Proposal to amend UN Regulation No. 110 Shut off Valve

GRSG-119 / October 2020

Proposal: Add alternative configuration with a «shut-off type excess flow valve» to UN R110

Excess flow valve (EFV) - Structure and Operation

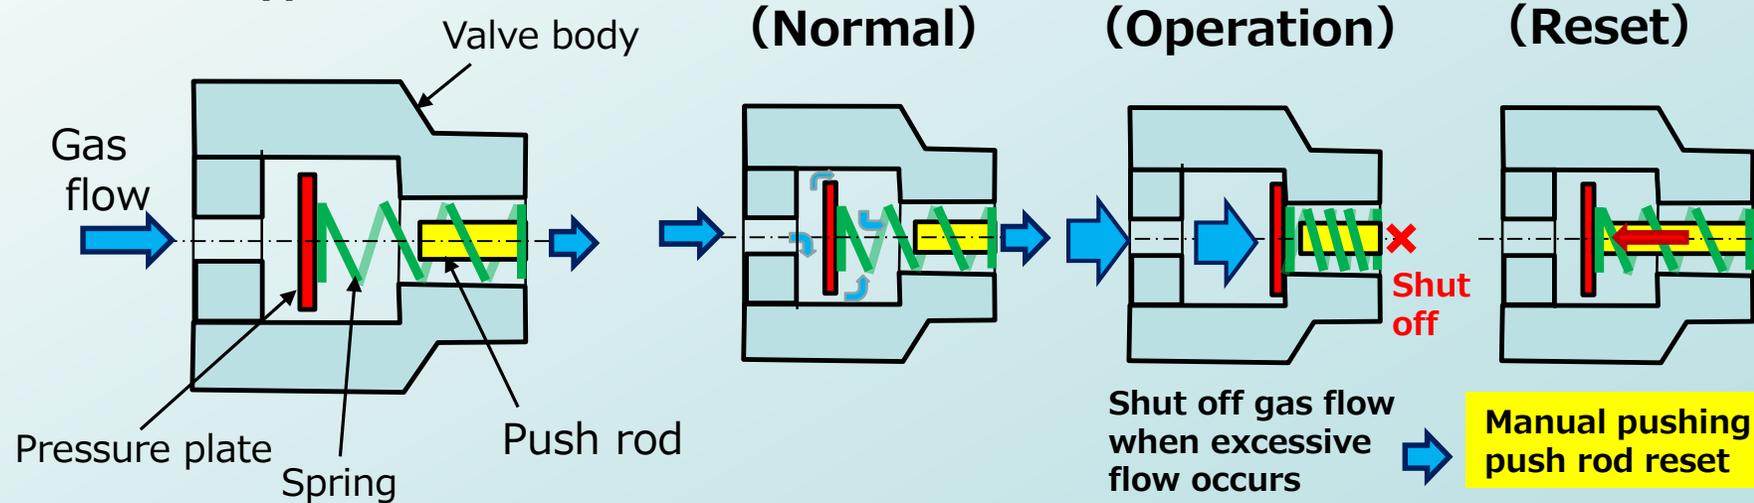
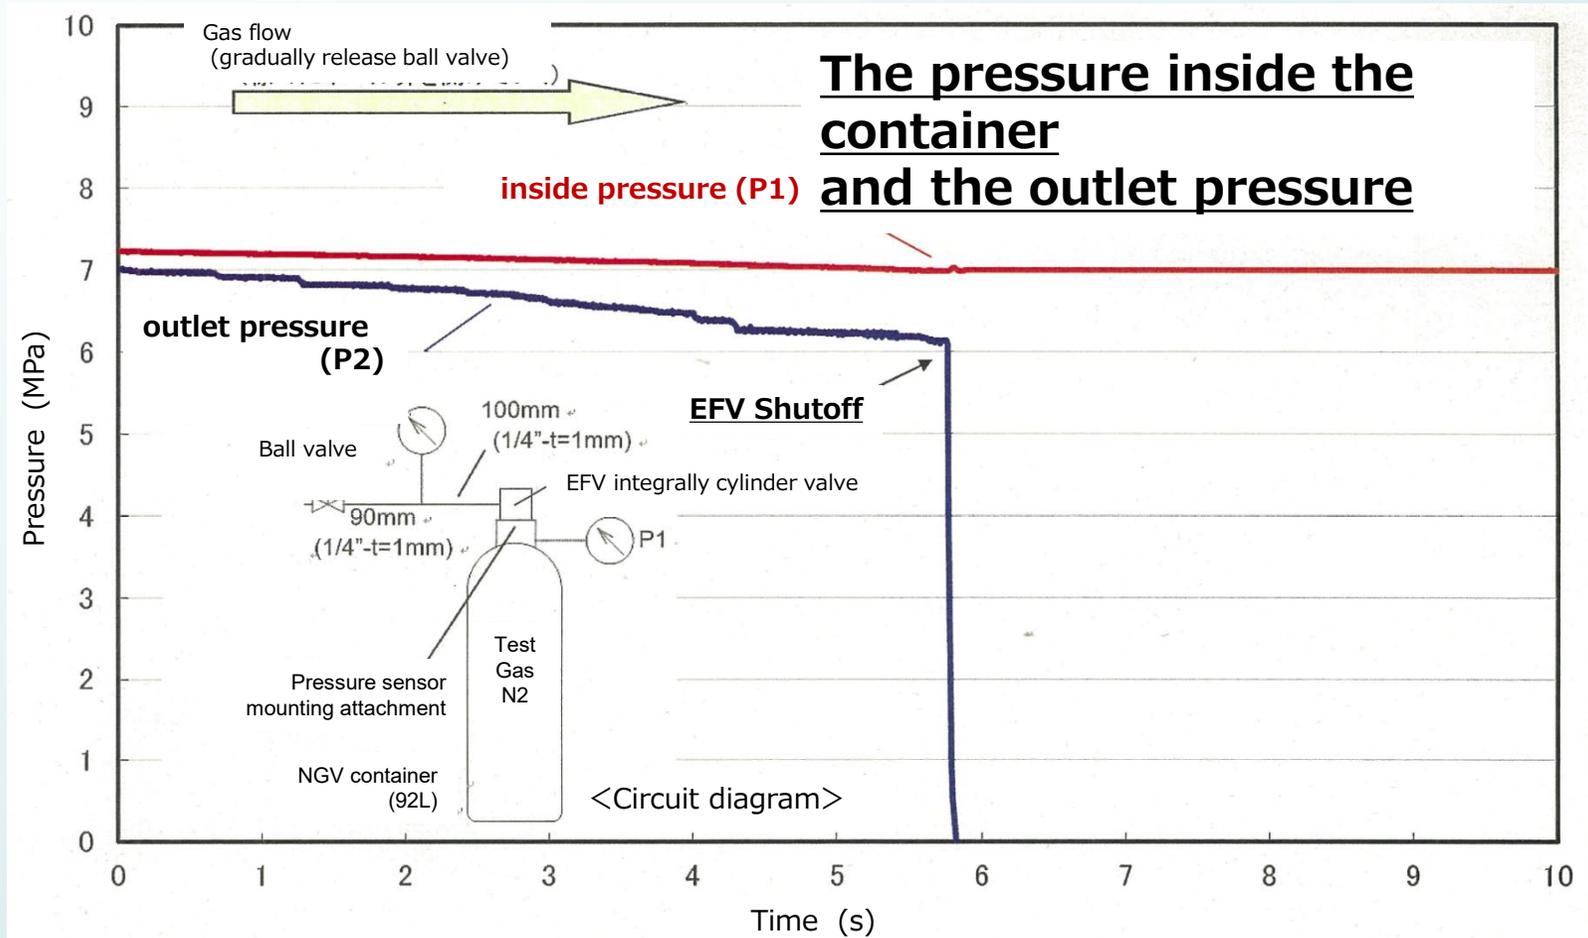
【 Pressure-equalization type 】

Gas flow restricted when excessive flow rate occurs

Small amount of gas is allowed to flow, and when it is equalized, automatic return

【 Shut-off type 】

Shut off gas flow when excessive flow occurs

Manual pushing push rod reset

Operation performance of fuel shutoff type EFV

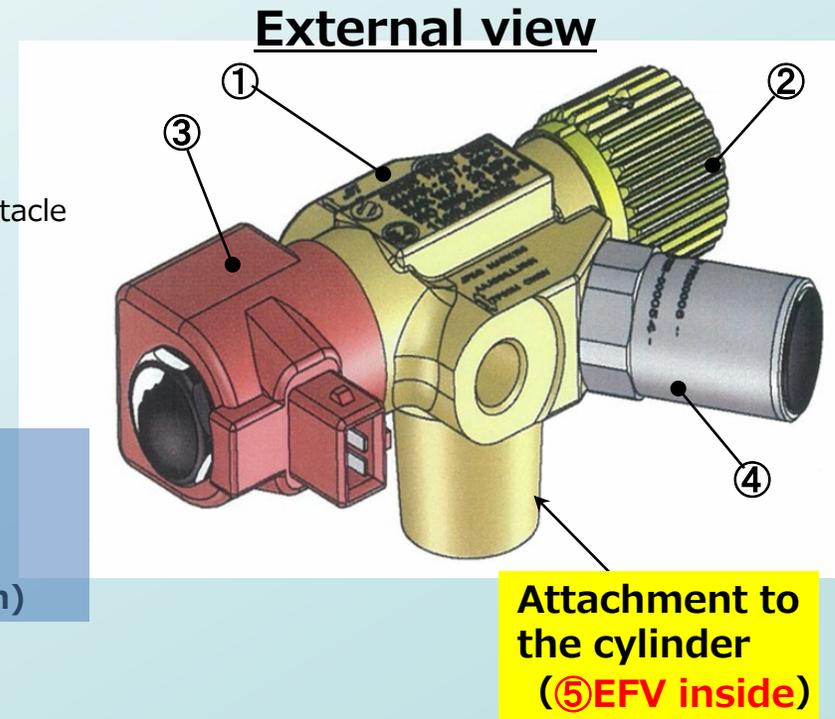
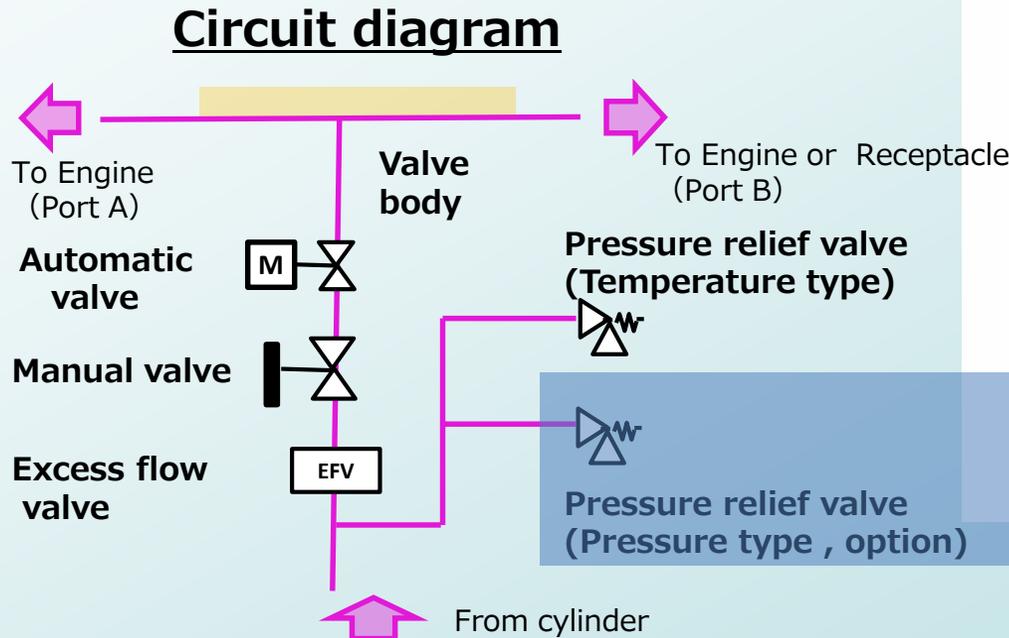
Since the Excess flow valve is inserted in the threaded portion for attachment to the cylinder, it is difficult to break. On the other hand, the automatic valve is exposed to the outside.

Excess flow valves are more suitable than automatic valves, for preventing fuel outflow during accidents.

(1) Setup of automatic valve (AV)

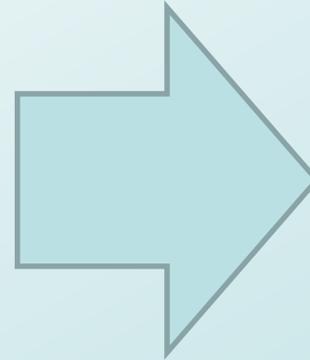
- adds potential leaking points upstream of the AV
- slow leaks cannot be avoided because they are not detected by EFVs

UNR110 Annex 3A – Appendix A

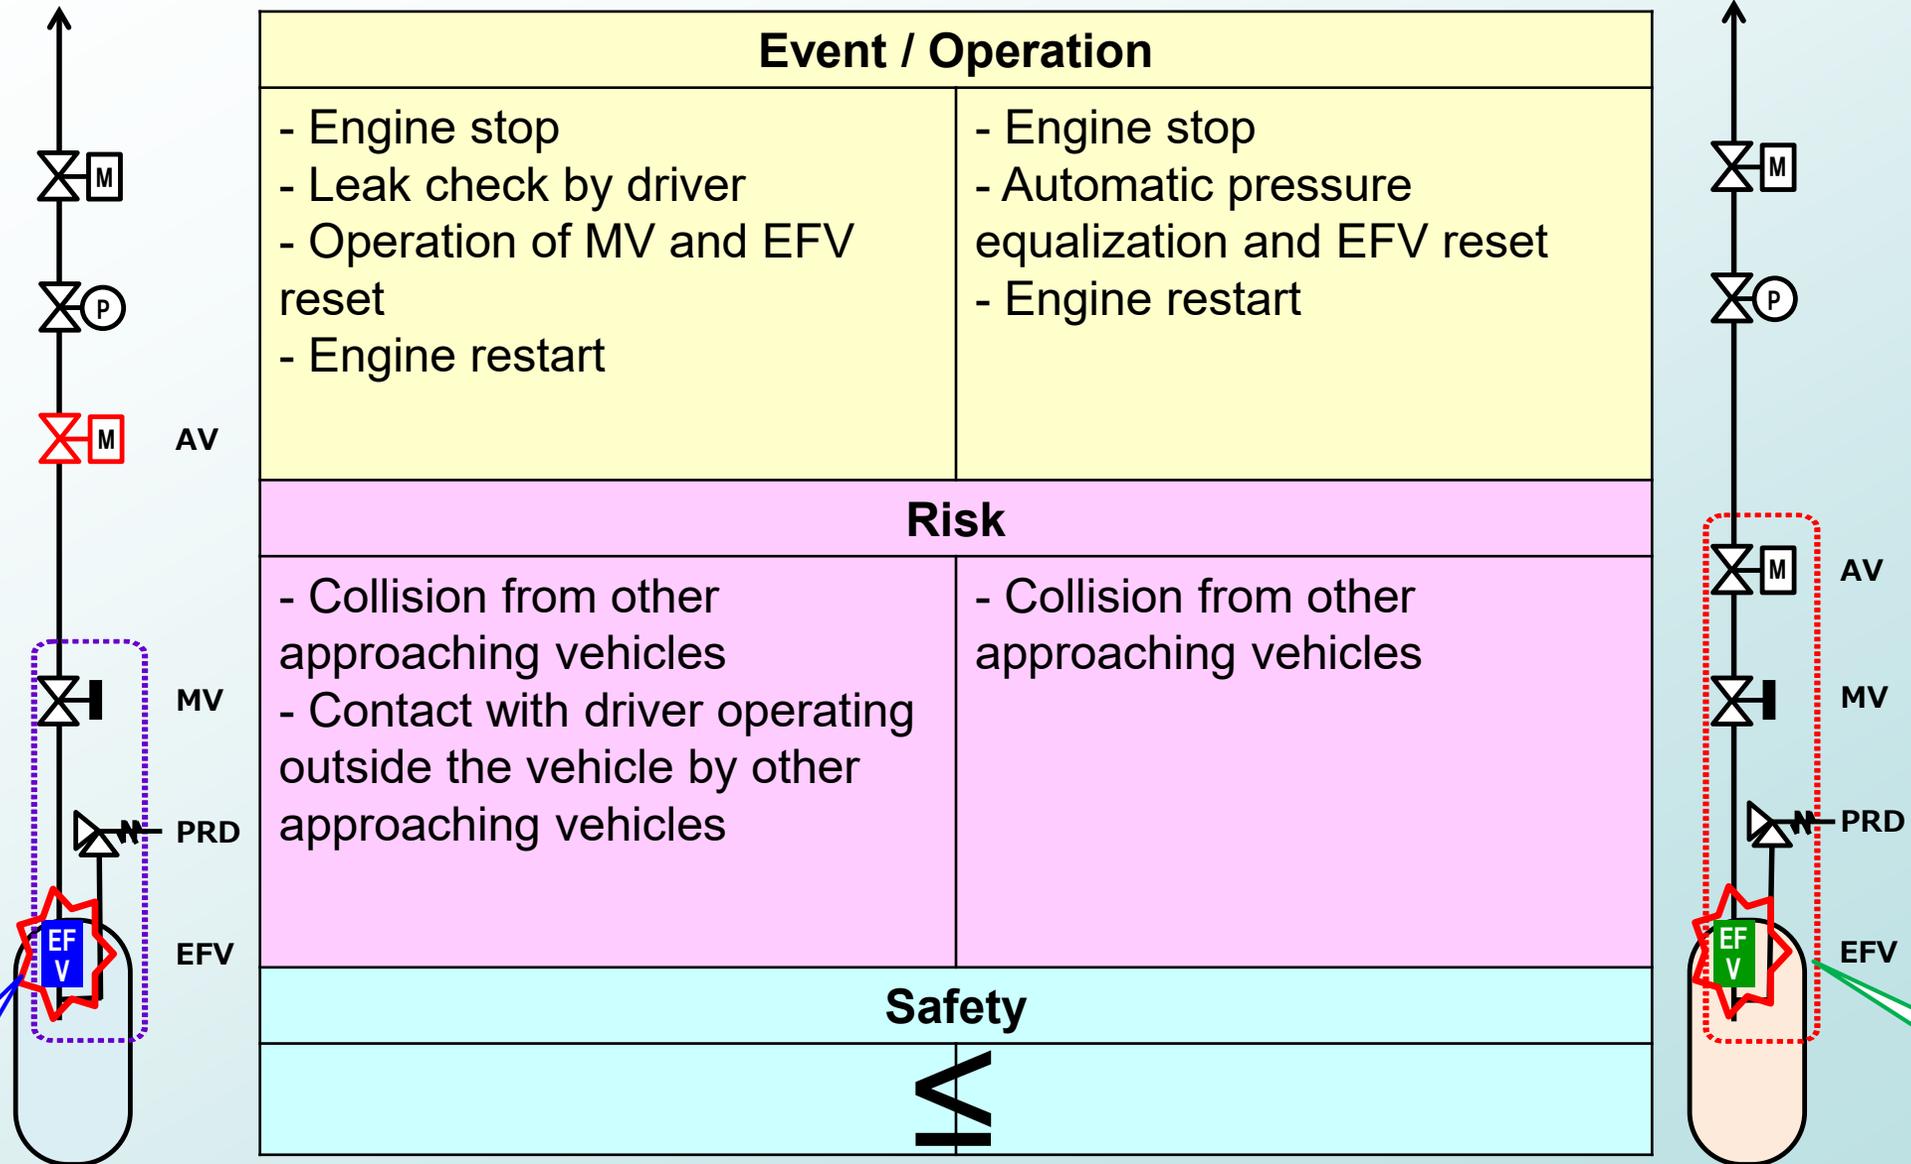
Connection points upstream of AV exist and are allowed in UNR and ISO.

PRDs for cylinders of long length are assembled by extending from the opposite end of the cylinder with piping connection.

If the cylinder is fitted with a pressure relief device at one end, the fire source shall commence at the opposite end of the cylinder. If **the cylinder is fitted with pressure relief devices at both ends, or at more than one location along the length of the cylinder**, the centre of the fire source shall be centred midway between the pressure relief devices that are separated by the greatest horizontal distance.

Risk Assessment Case 1 Malfunction of EFV

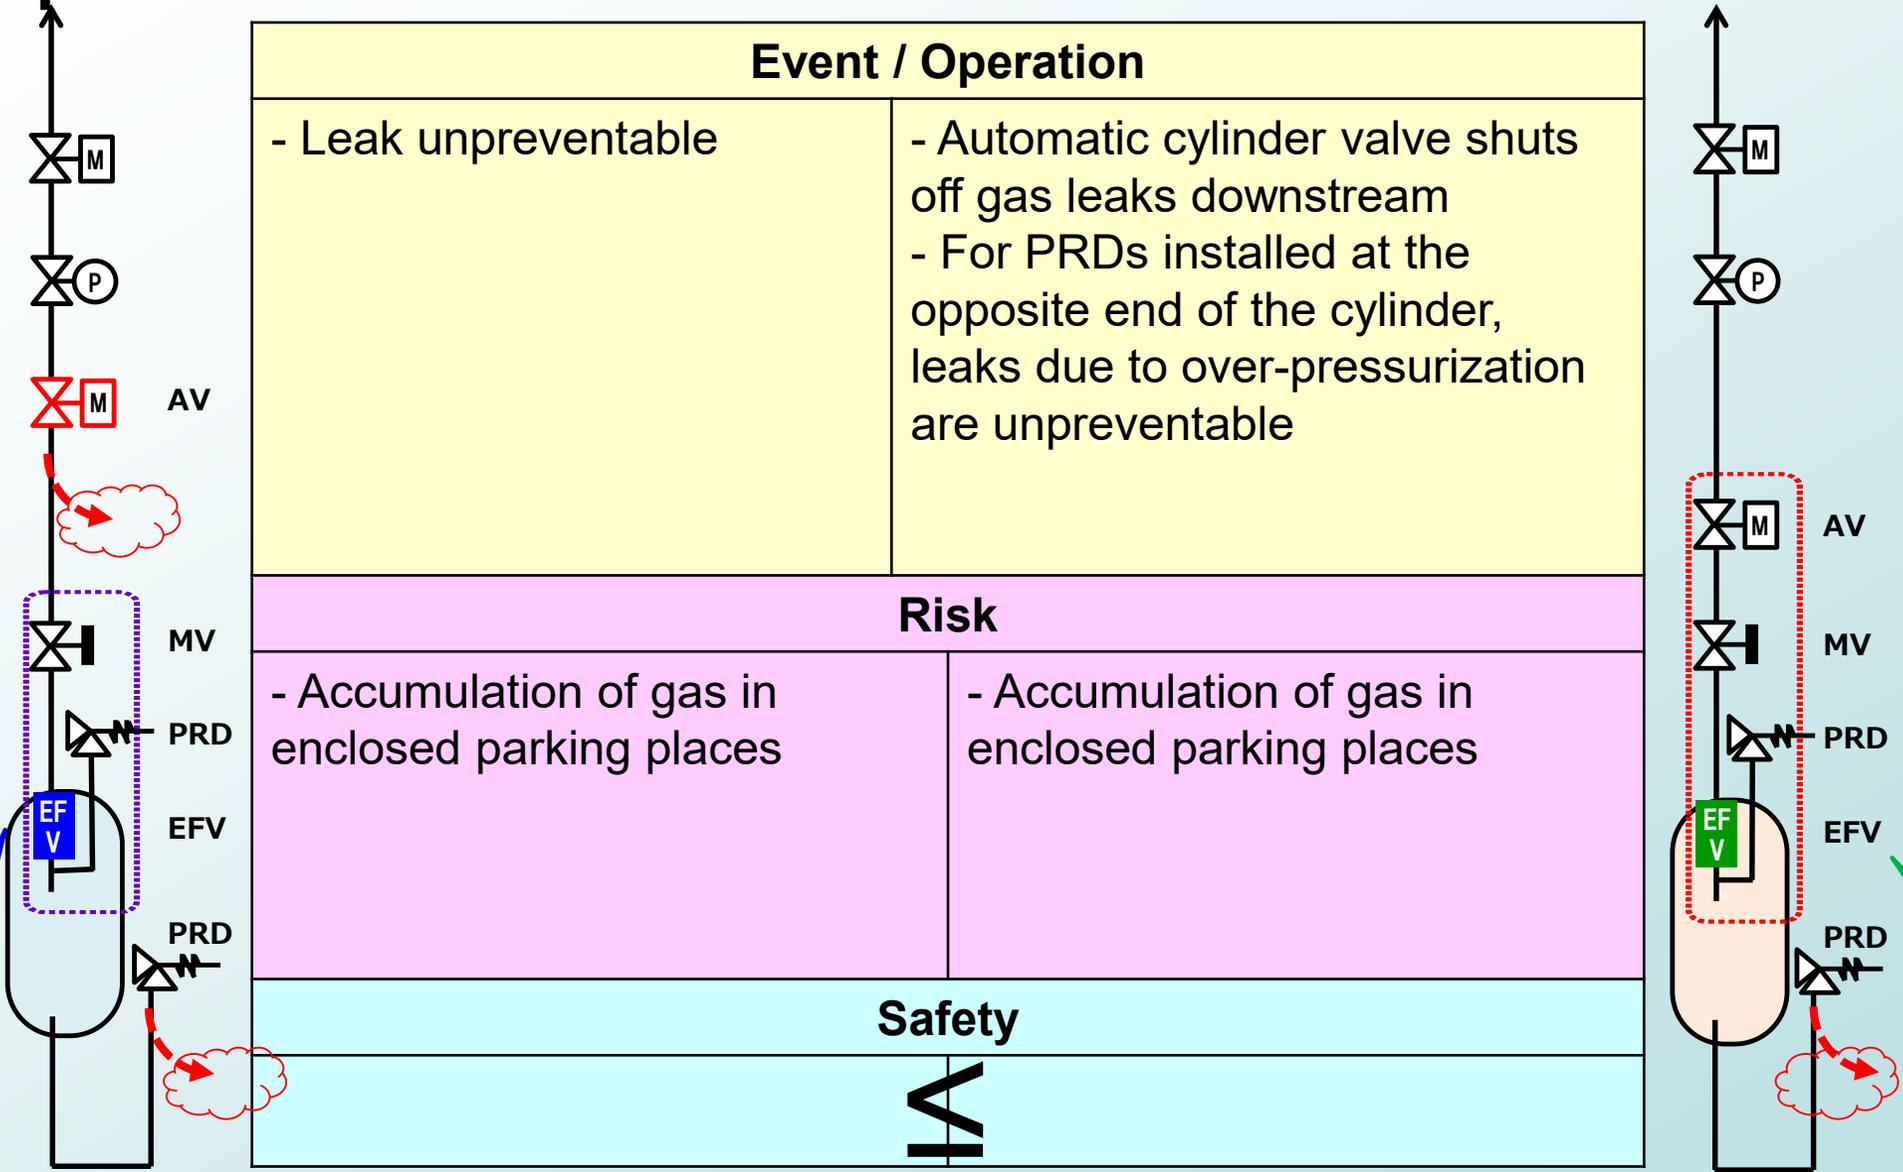
Shut-off type

Pressure-equalization type

Assessment: Accessibility to reset shut-off type EFVs

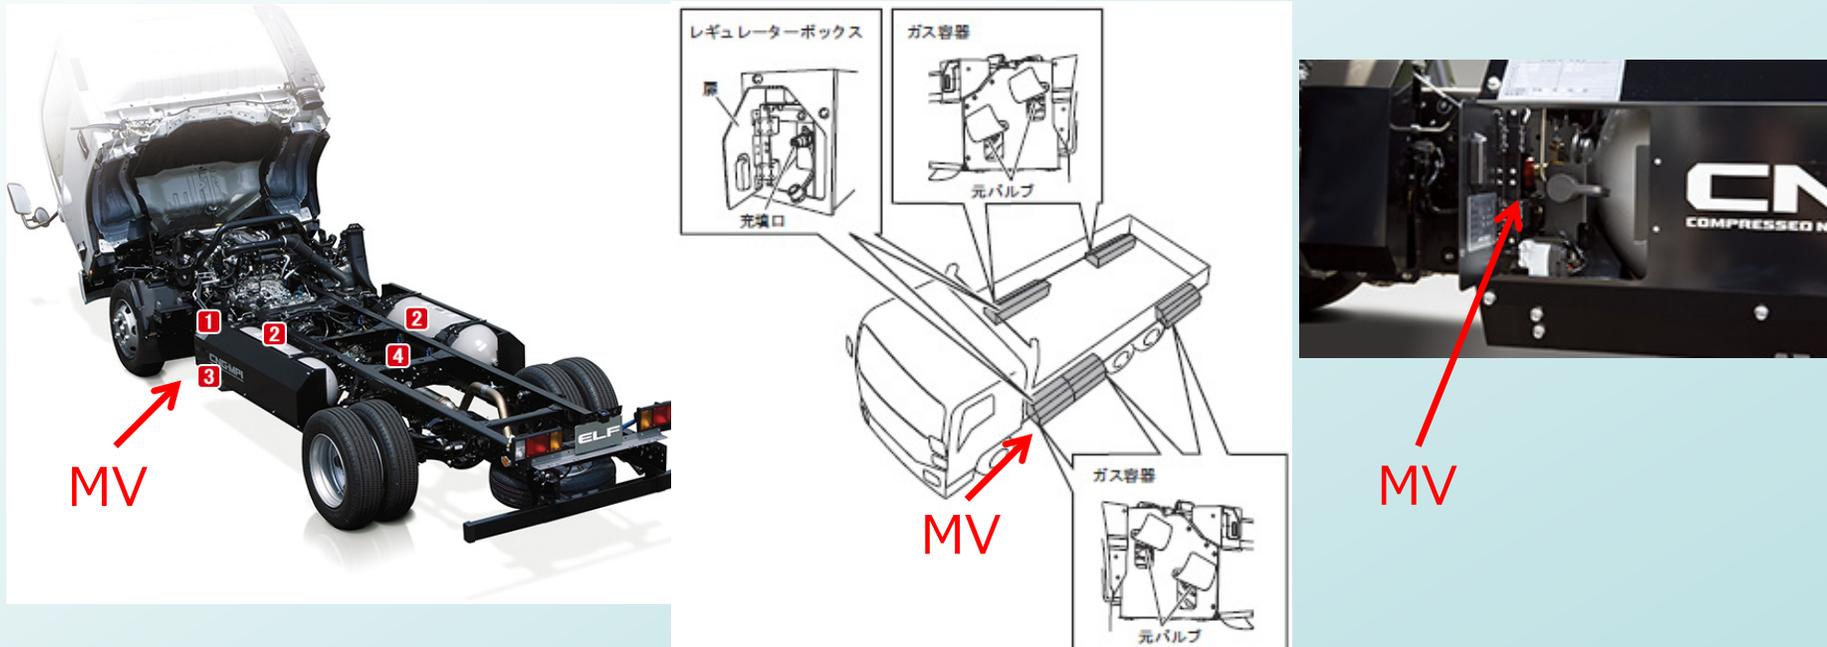
For some vehicles it is actually easy to access and operate manual valves.

Shut-off type EFVs should be allowed based on the ease of access by the configuration of assembly.

4 Requirements

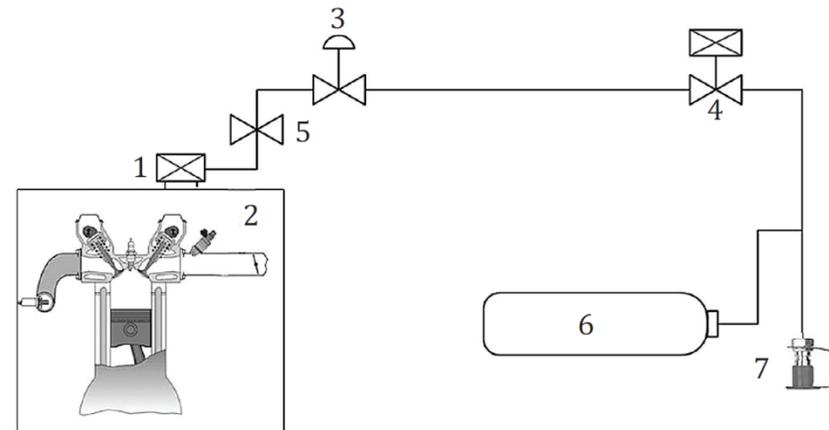
ISO15501-1 requires Automatic Valves installed “directly” on cylinder, not “rigidly”.

“Directly” should be interpreted “without other components in between (just piping allowed)”.

— an automatic valve to be installed directly on every CNG cylinder with a manual valve rigidly fixed to the CNG cylinder, which may be integrated into the automatic valve.
